Direction générale de l'aviation civile France GSAC publication	AIRWORTHINESS DIRECTIVE No F-2003-291 R1		Distribution: B	Issue date: July 06, 2005	Page : 1/3
	This Airworthiness Directive is published by the DGAC on behalf of EASA, Airworthiness Authority of the State of Design for the affected product, part or appliance.			<i>Translation of « Consigne de Navigabilité » of same number. In case of difficulty, reference should be made to the French issue.</i>	
<p align="center">No person may operate an aircraft to which an Airworthiness Directive applies, except in accordance with the requirements of that Airworthiness Directive, unless otherwise agreed with the Authority of the State of Registry.</p>					
Corresponding foreign Airworthiness Directive(s): Not applicable			Airworthiness Directive(s) replaced: 2003-291 original issue		
Person in charge of airworthiness: AIRBUS SAS			Type(s): A300 aircraft

Type certificate(s) No. 72 TCDS No 145					
ATA chapter: 22, 27		Subject: Flight controls - Pitch trim

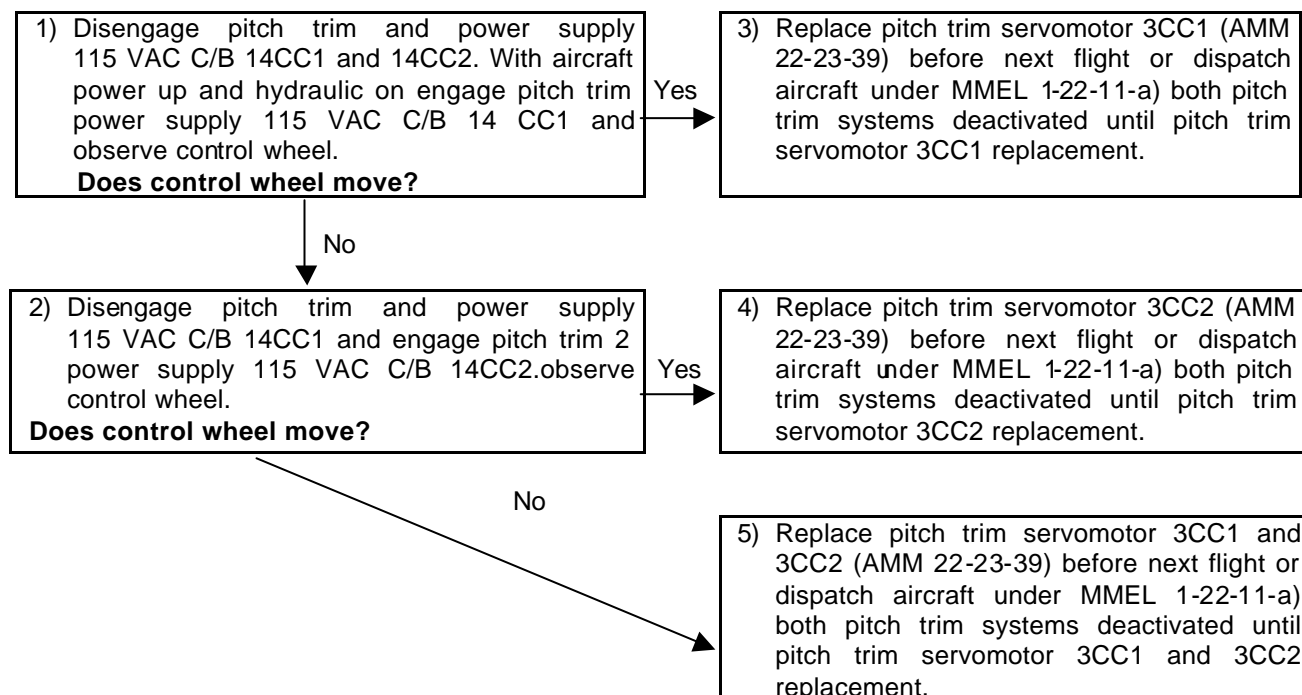
From the effective date of this AD at original issue, accomplish after each landing and before shutting down the engines, the following operational procedure:

"APPROACH AND LANDING

PITCH TRIM

- Set TRIM to 1° UP
- Set both PITCH TRIM levers to OFF

Note: Check pitch trim wheel and report any movement to maintenance."
